MARKET GARDEN CITY WOLVES LANE

MINOR MATERIAL AMENDMENT REPORT

Wolves Lane Horticultural Centre
Wolves Lane
Haringey N22 5JD

January 2023

1.1 SITE - PHASING PLAN

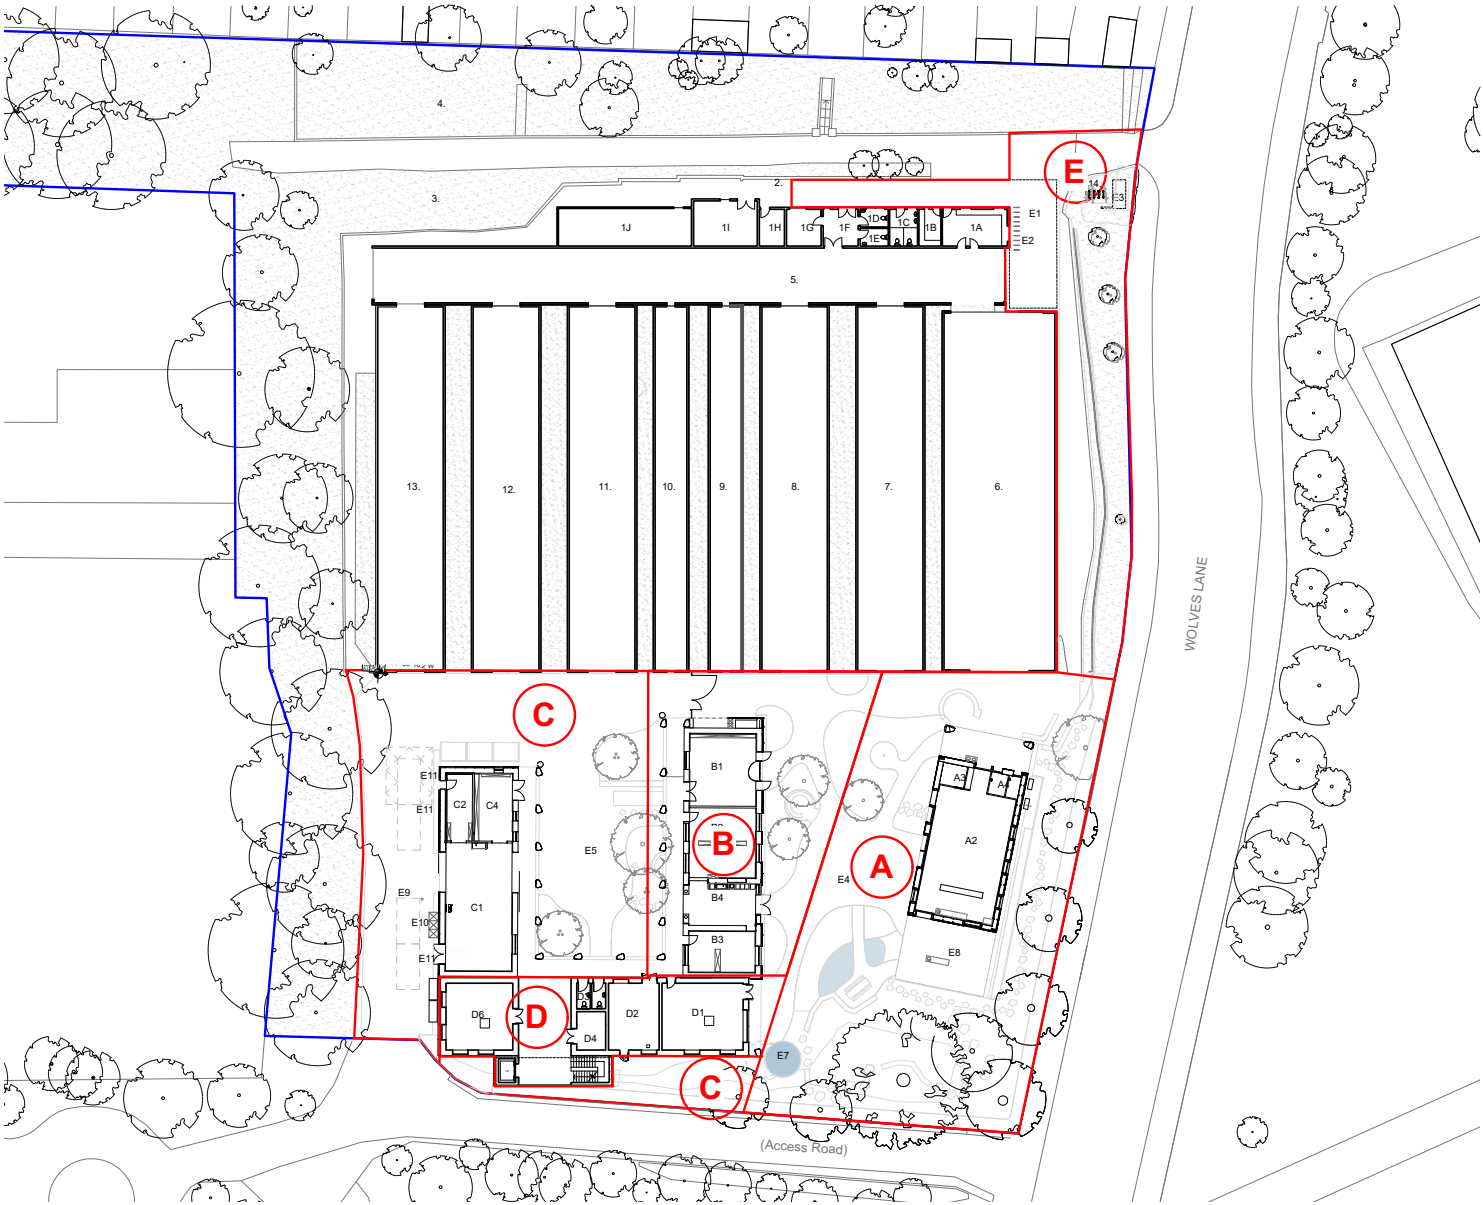
MMA - NEW ADDITIONAL drawing (not part of the original drawing set)

Phases A, B, and C:
Improved replacement facilities for existing not fit for purpose spaces. All phases include sufficient landscaping to allow for off-grid drainage from the buildings proposed during the phase.

Phase A:
Indoor and outdoor gathering spaces for members and the public (Indoor gathering currently taking place mainly in the existing uninsulated glasshouses)

Phase B:
Replacement building for existing Classroom, offices and member's amenities and a dedicated work yard with better separation from the publicly accessible spaces.

Phase C:
Replacement building for existing barn and workshop with less energy intense cold store. (The existing barn has asbestos in the roof)

Phases D & E:
Up-scaling of operations and improved site signage.

Phase D:
Building D including additional classrooms, offices, storage and other amenity spaces as per the original planning application.

Phase E:
Improved main visitor's entrance, improved site signage, and access route.

2.1 PROPOSED SITE PLAN ROOF

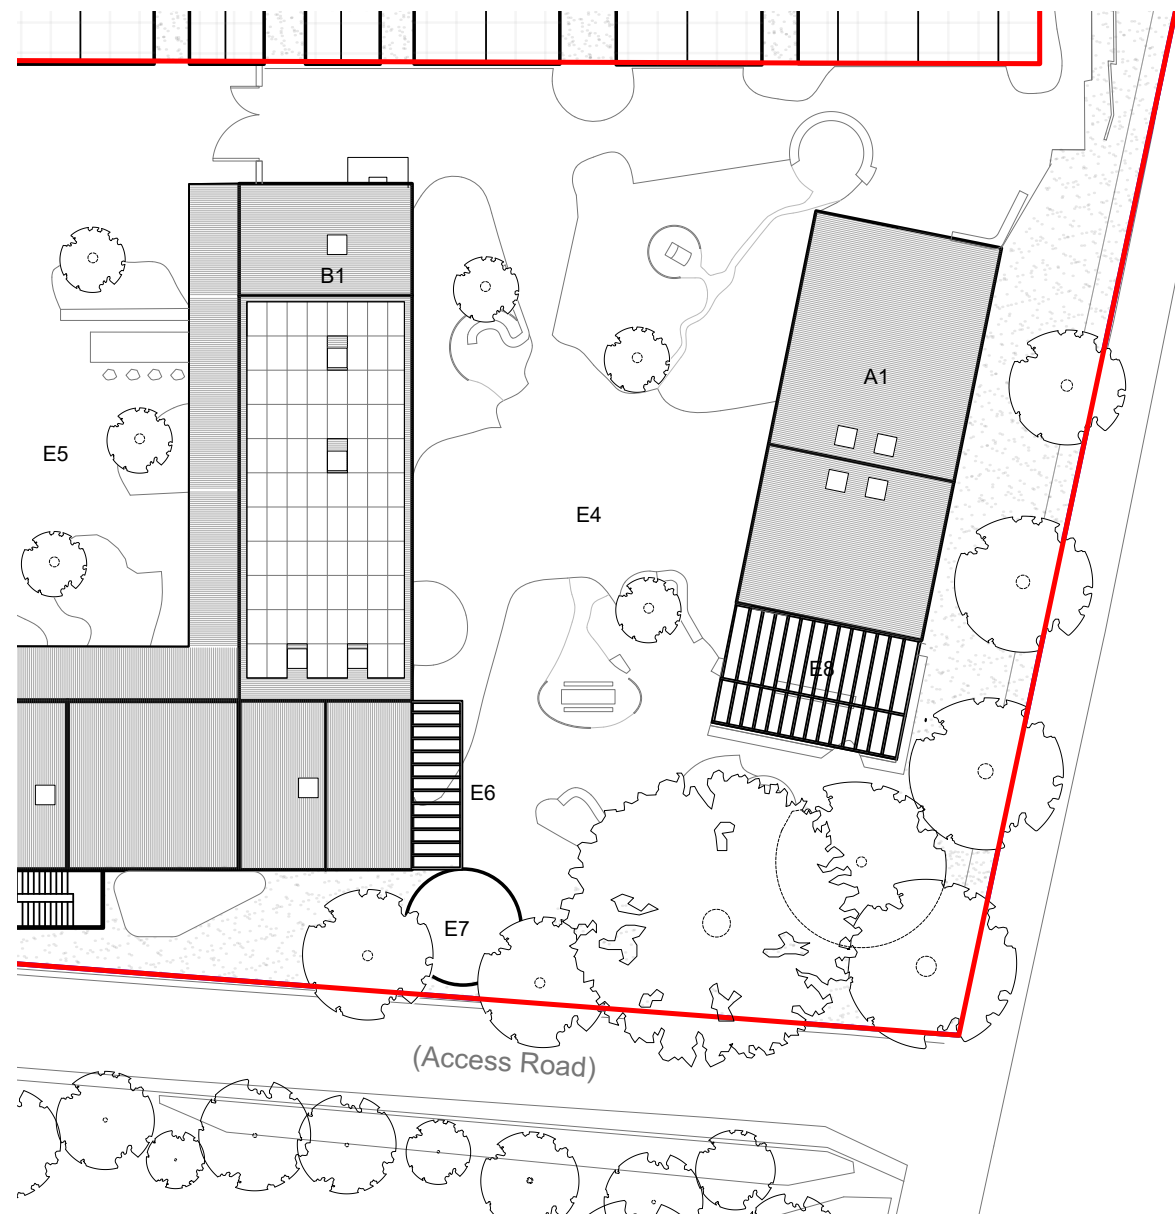
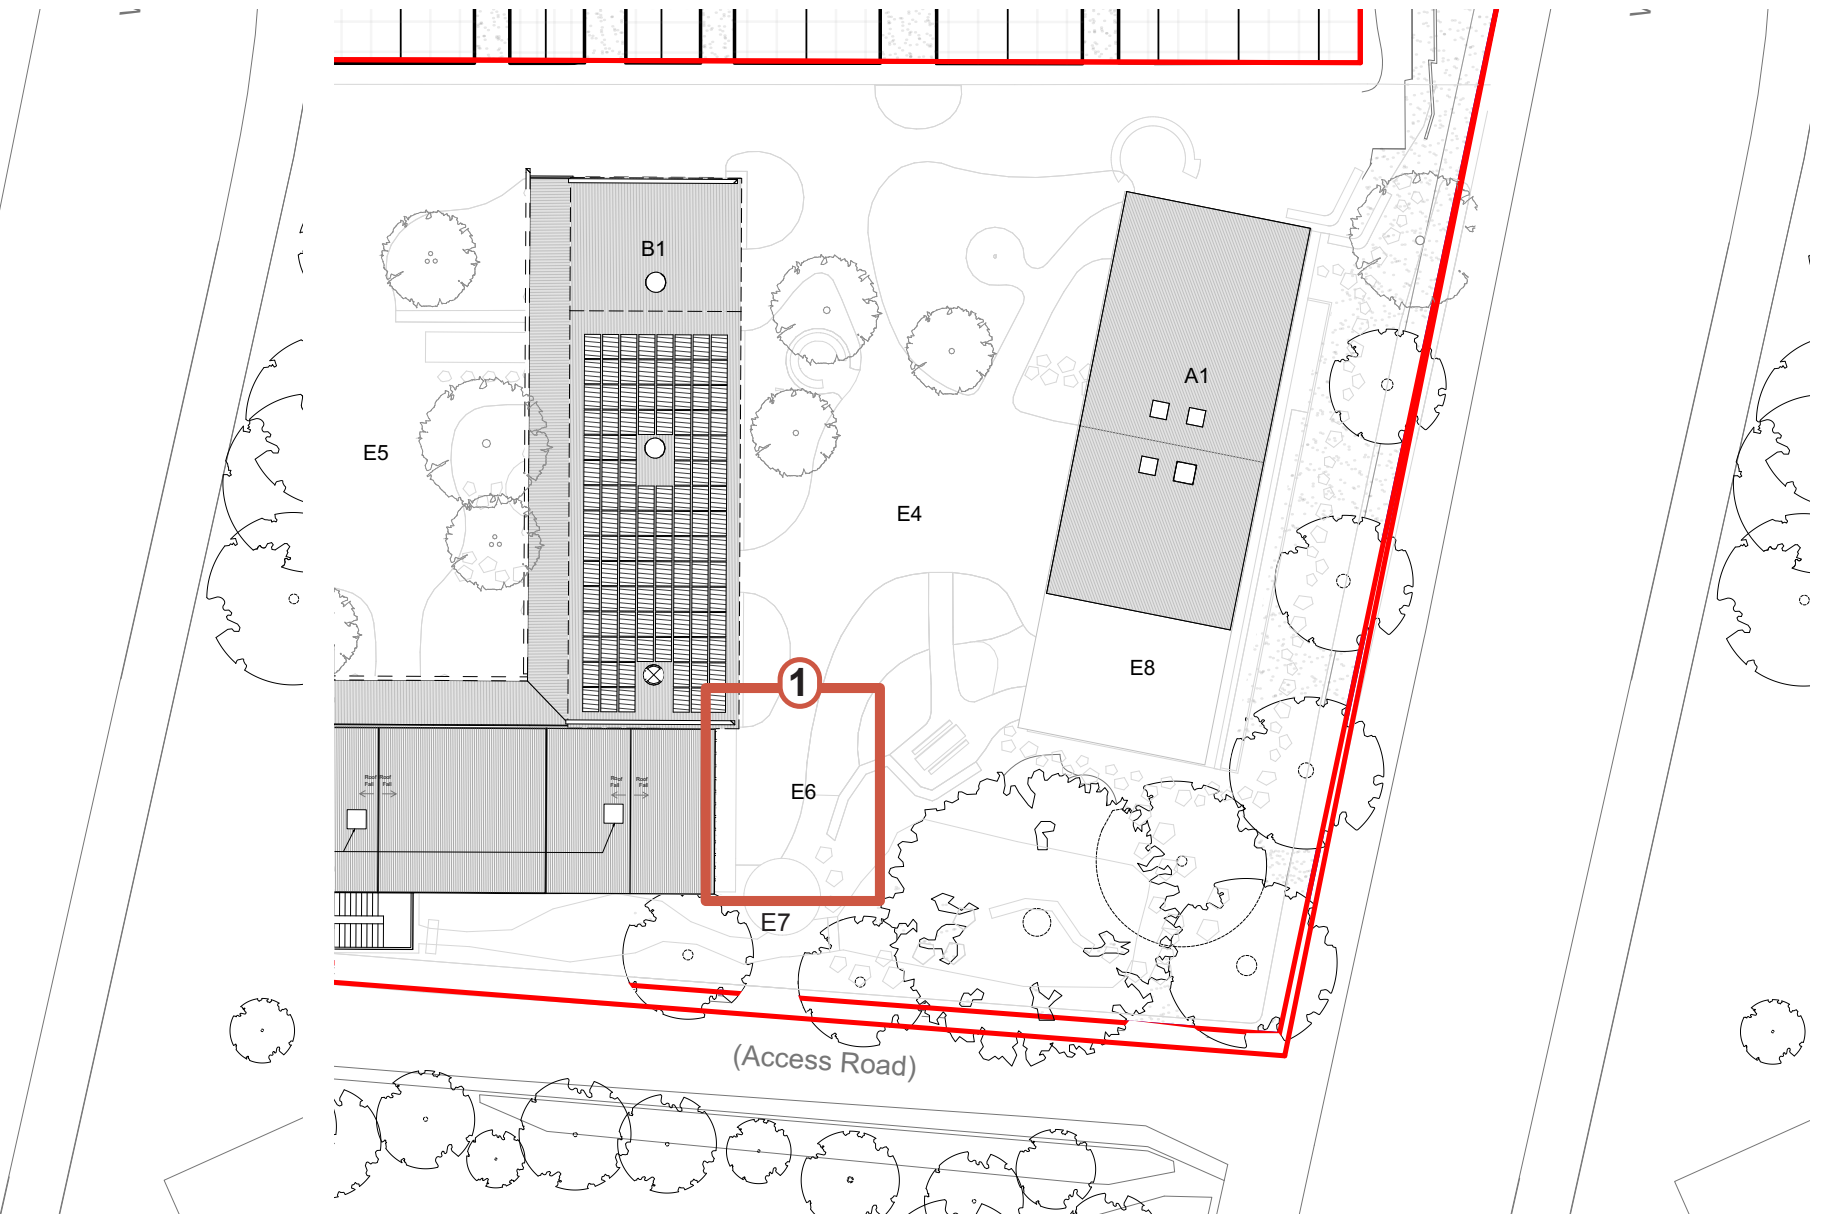
1 - Loggia next to building D removed to allow for retention of the existing water tank for rain water harvesting.

2.2 PROPOSED SITE PLAN GROUND FLOOR

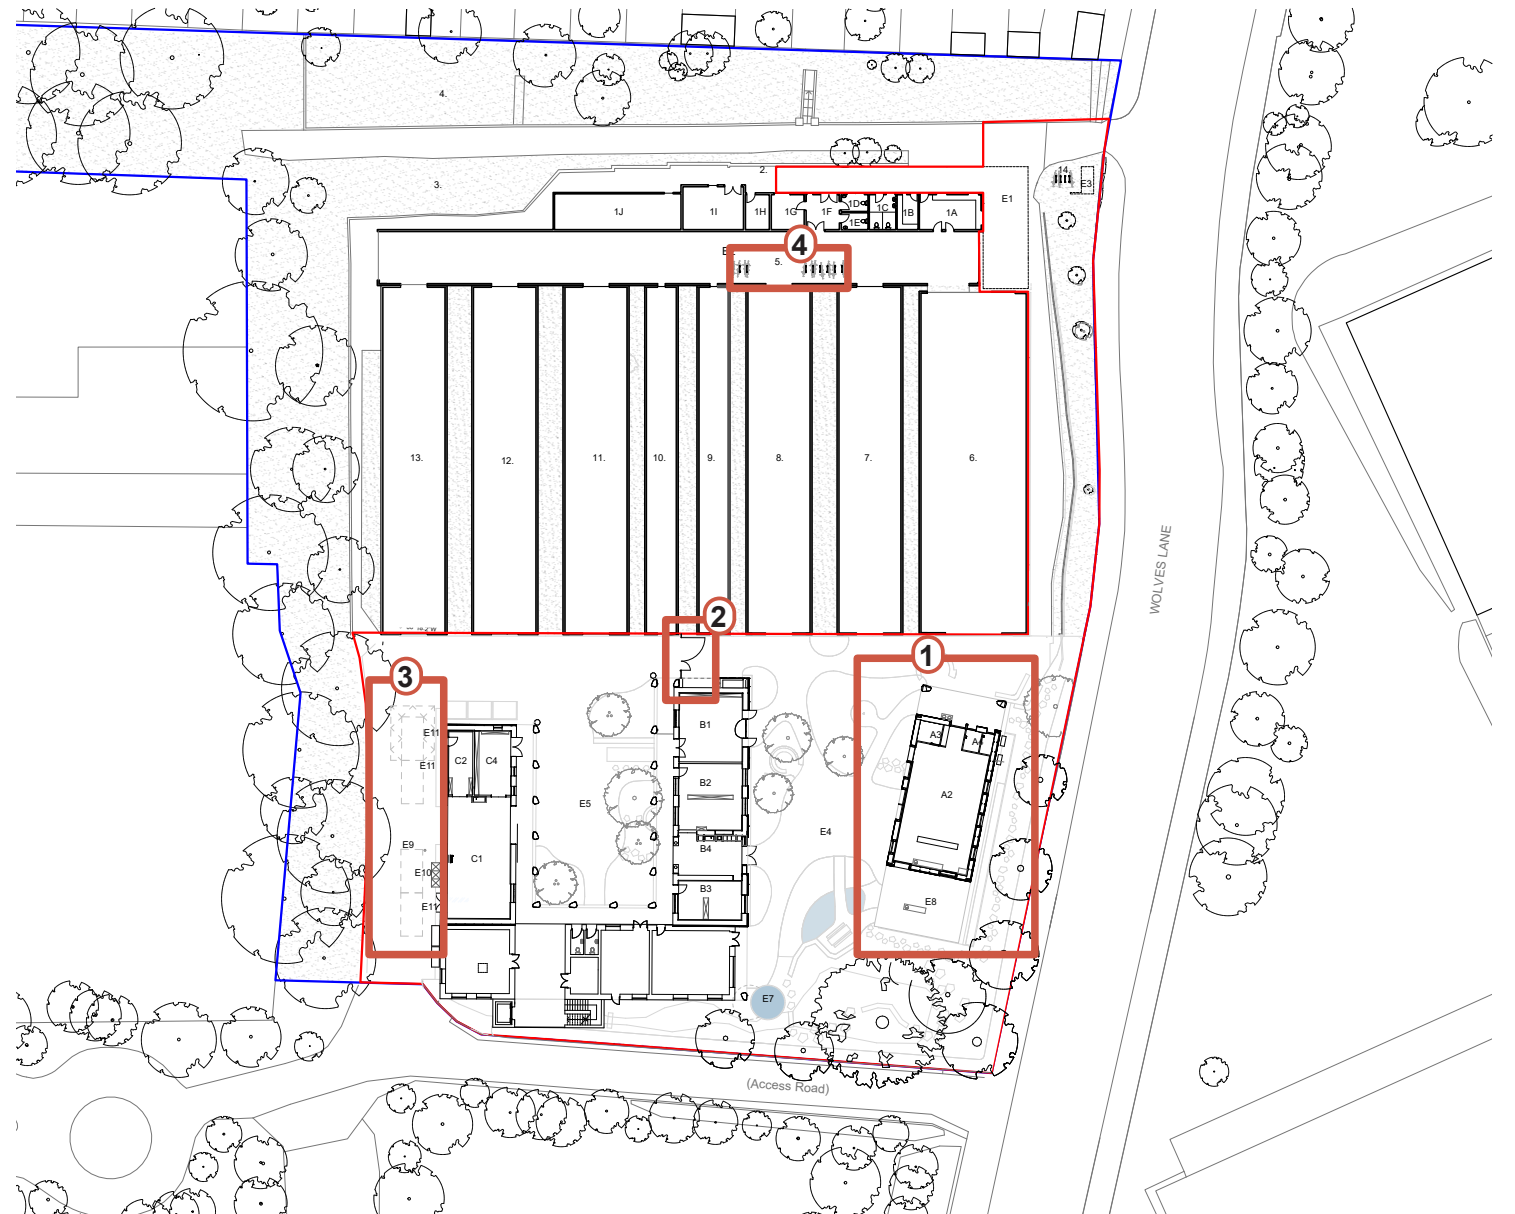
- 1 - Building A shifted west by 1m to reduce impact of embankment on its foundations.
- 2 - Gate for cars and pedestrians added to outline safe line between public access and user's only area.
- 3 - Location of car parking bays adjusted to allow for a more central location of the composting area between existing and proposed buildings.
- 4 - Bicycle parking re-located into greenhouse (5) for secure and covered parking.

2.3 PROPOSED STREET ELEVATIONS

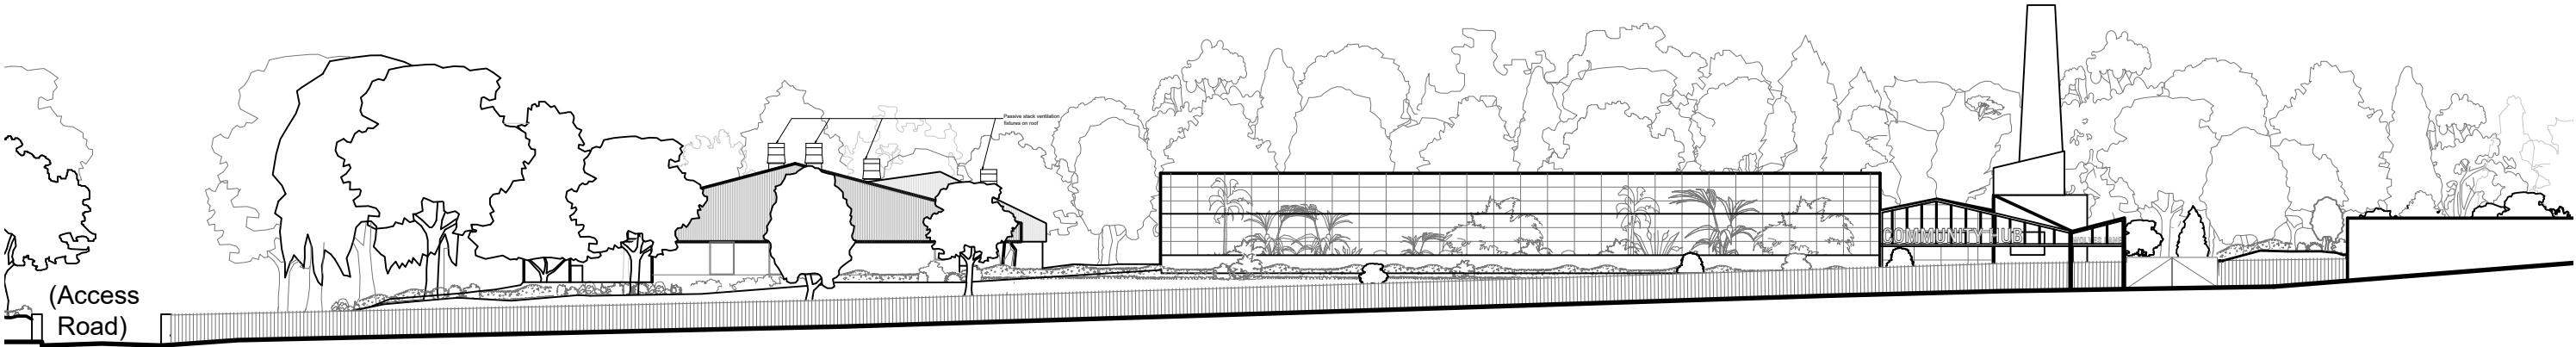
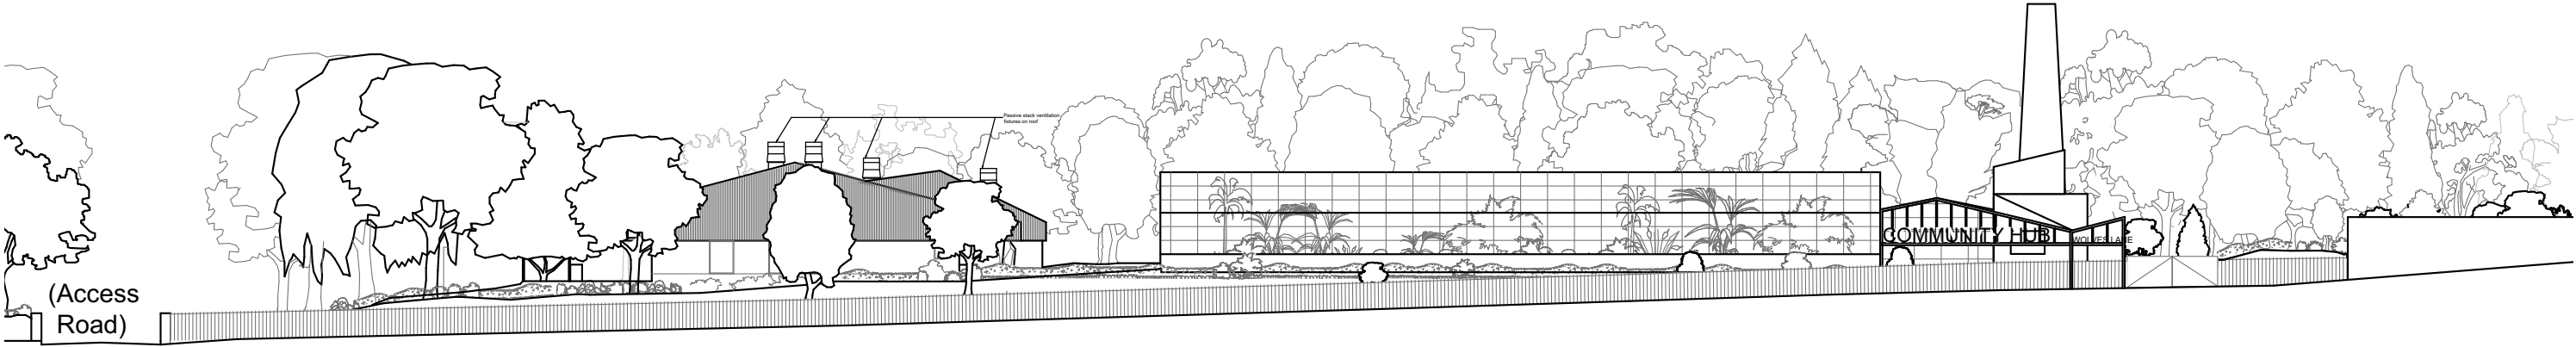
1 - Building A shifted back by 1m . This change is not visible in this drawing.

2.4 PROPOSED STREET ELEVATIONS

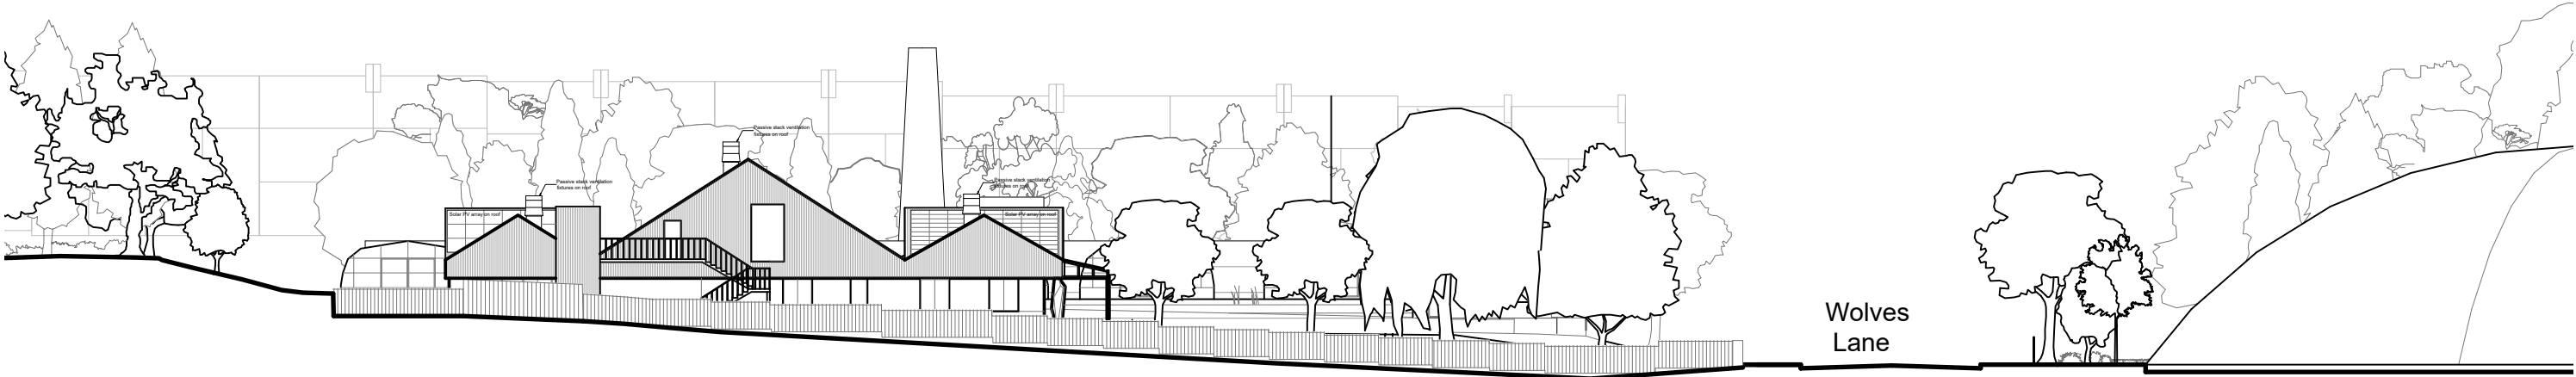
- 1 - Building A shifted back by 1m . This change is not visible in this drawing.
- 2 - Loggia next to building D removed to allow for retention of the existing water tank for rain water harvesting.
